Open issues and solutions for Backplane EEE Mode

Velu Pillai and Prakash Mukre
IEEE 802.3az, Quebec, April 2009

Open issues in the backplane PCS FSM.

Figure 49-15—Receive state diagram

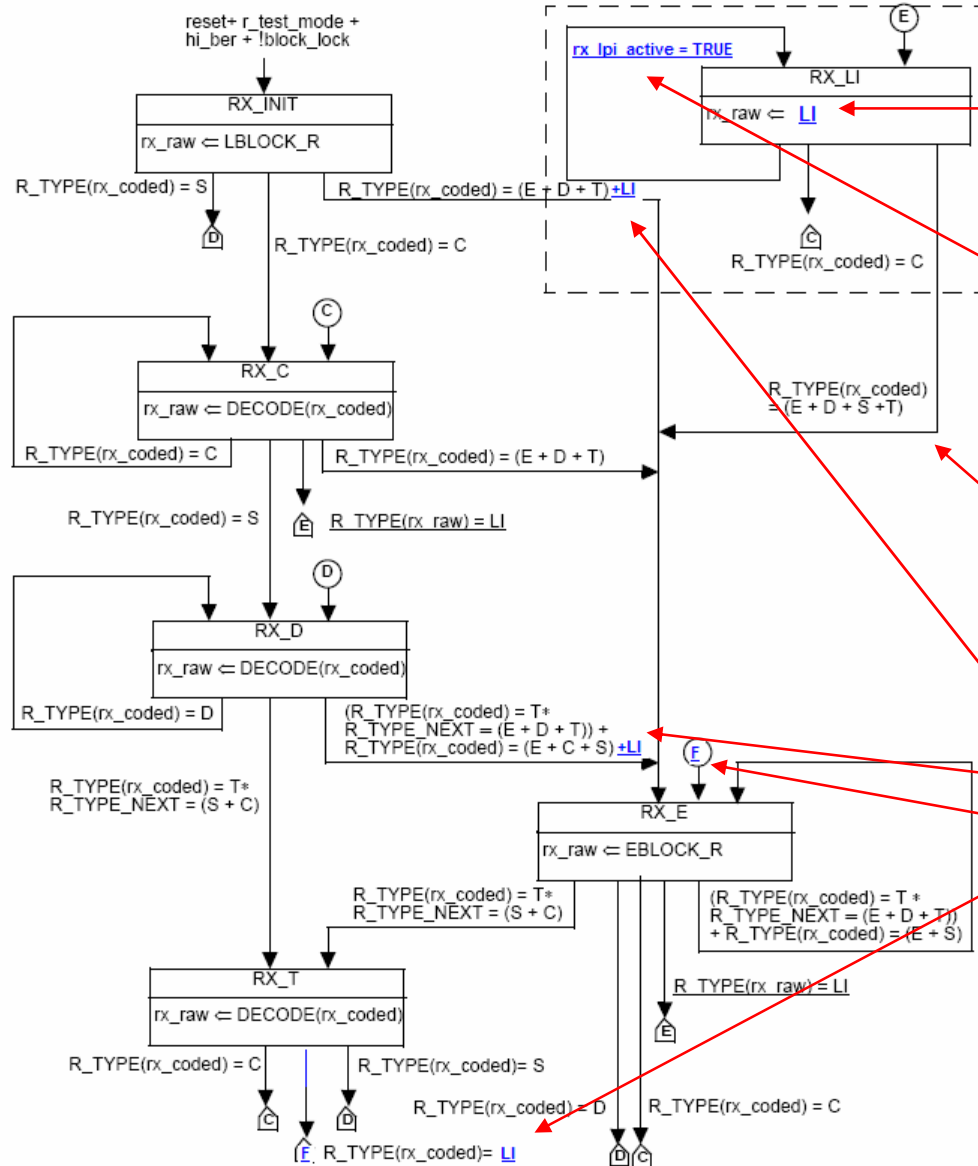
rx_raw <= LI is needed in this state to avoid asserting non LI during transitioning in and out of quiet mode.

Used "rx_lpi_active" to be consistent with 10GBASE-T state diagram. But without this

If the above two proposals are accepted, then this transition can be removed.

"F" is needed to handle LI code words appearing during non IPG states.

Clause 49: LPI Transmit state diagram (Fig 49-16)

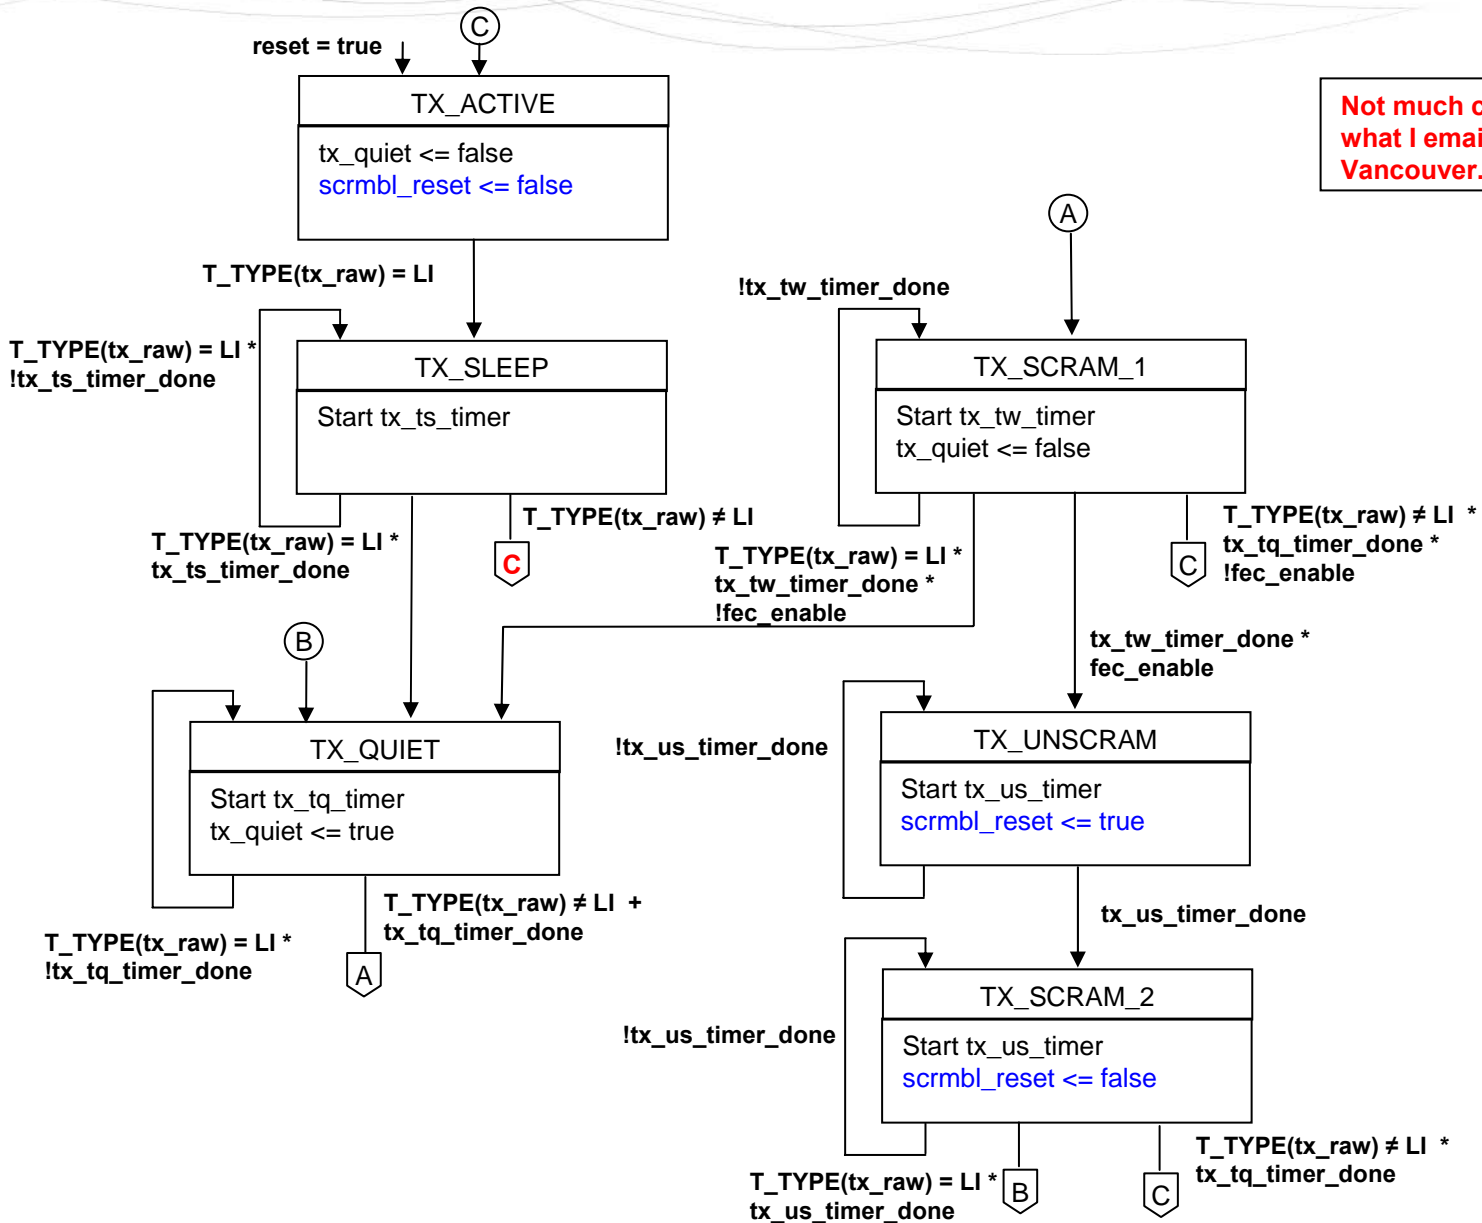
Not much change from what I emailed while at Vancouver.

Figure 49-13—BER monitor state diagram

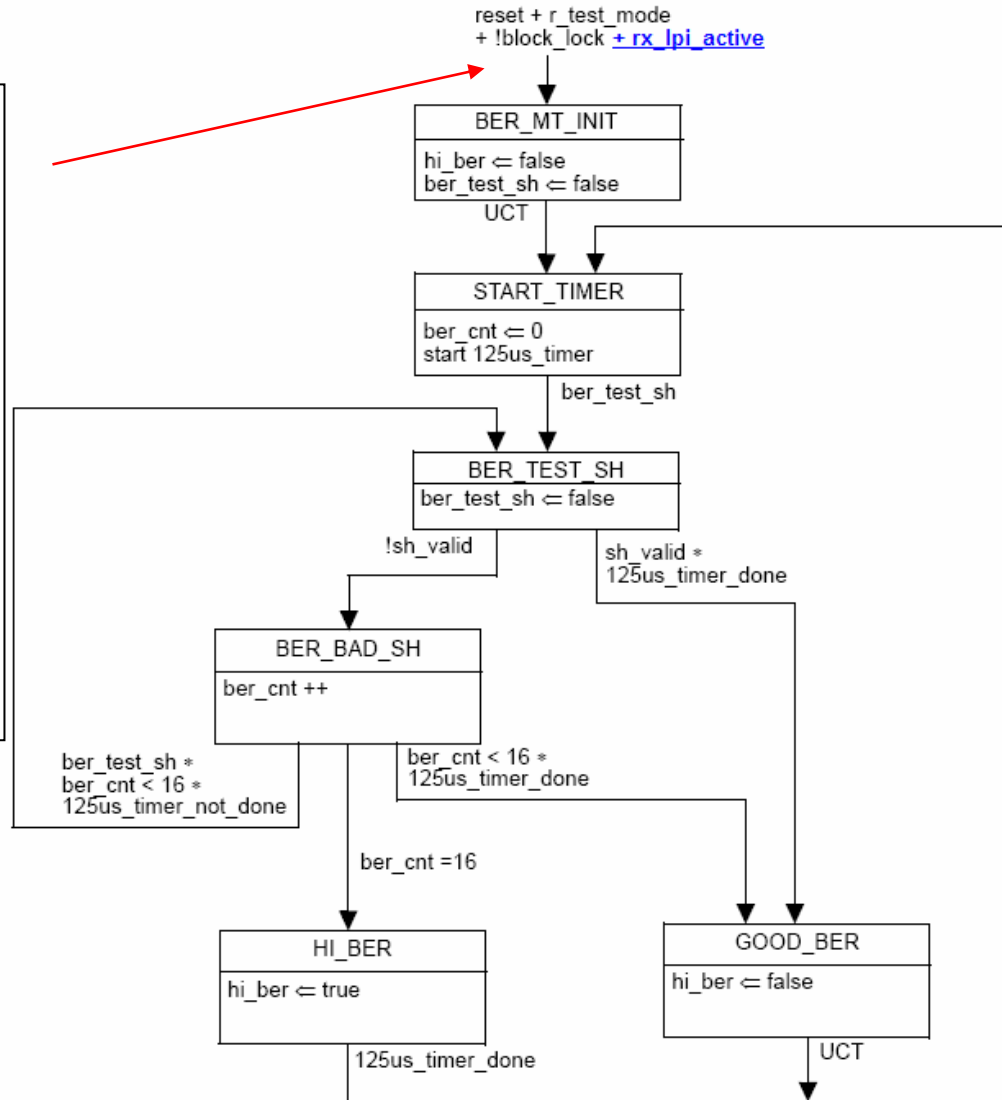
When in EEE mode, block_lock is latched in CI49 Rx Ipi fsm. During transitions in and out of Quiet mode, PCS gets some garbage data which will trigger hi_ber. When hi_ber is set, 10G-R link is dropped. To avoid this freeze the BER fsm during low power mode

Figure 48-9—PCS receive state diagram

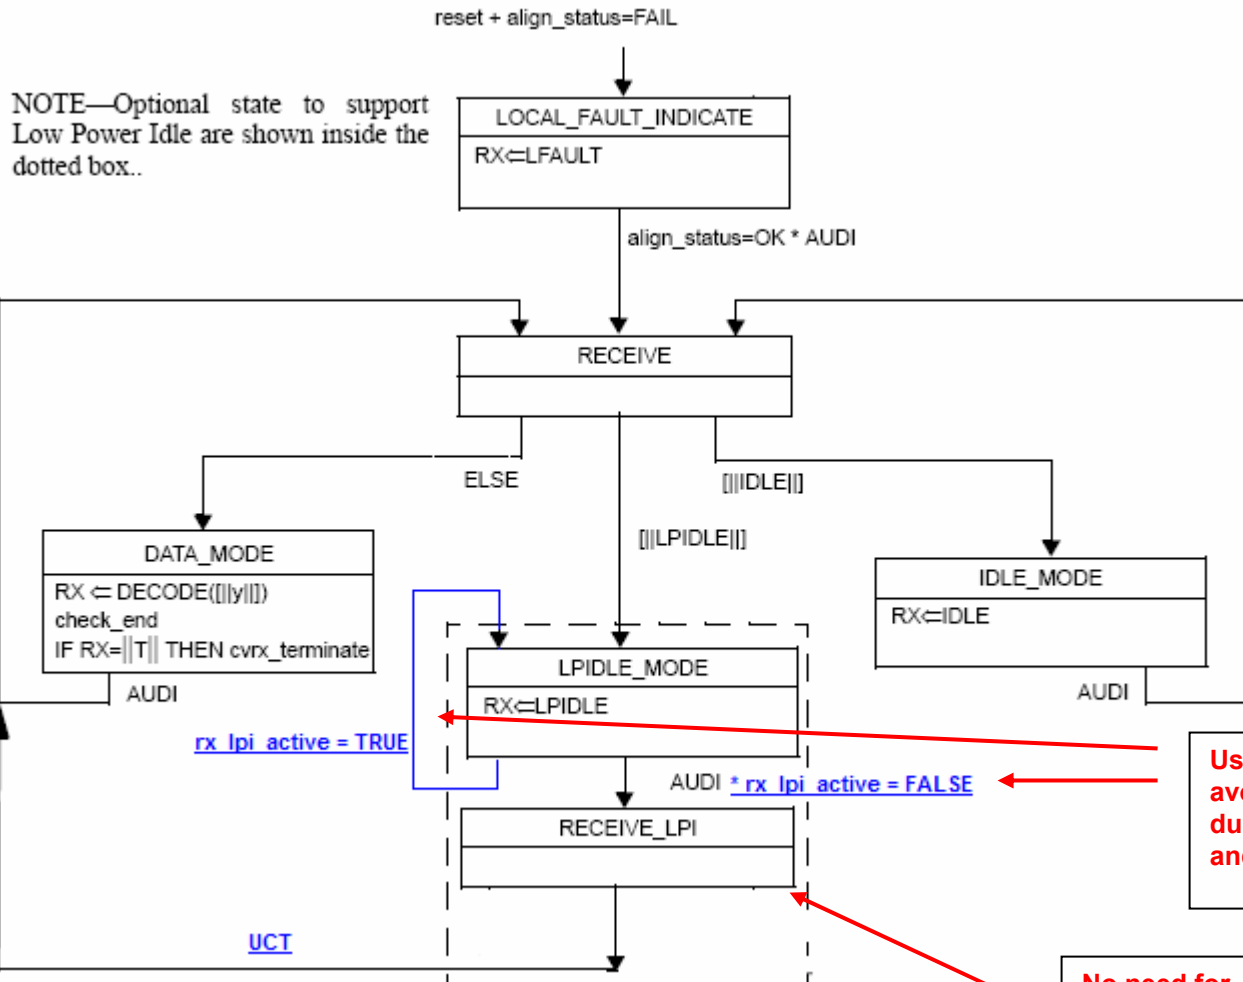
Used "rx_lpi_active" to avoid asserting non LI during transitioning in and out of quiet mode.

No need for "RECEVIE_LPI" state

CI36 Receive state diagram (Fig36-7a)

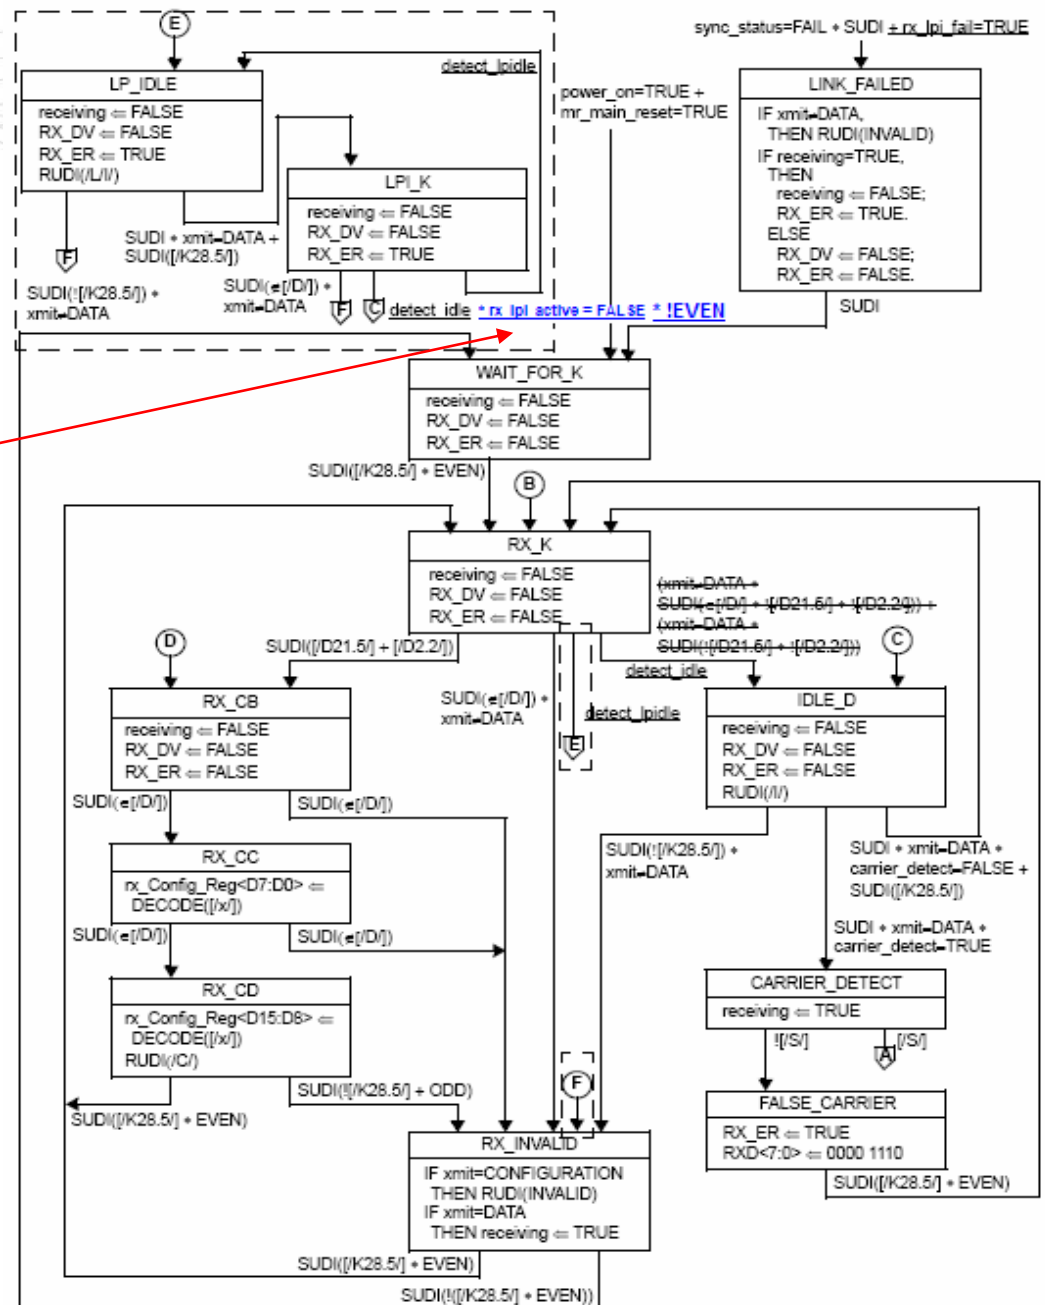
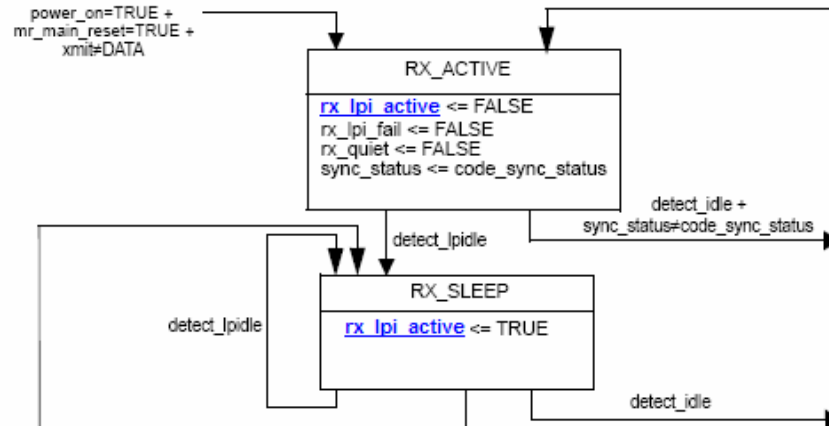
Without "rx_lpi_active" transition from LPI_K to IDEL_D can happen in and out of quiet mode.

Change Figure 36-7a, new states and transitions in dotted boxes
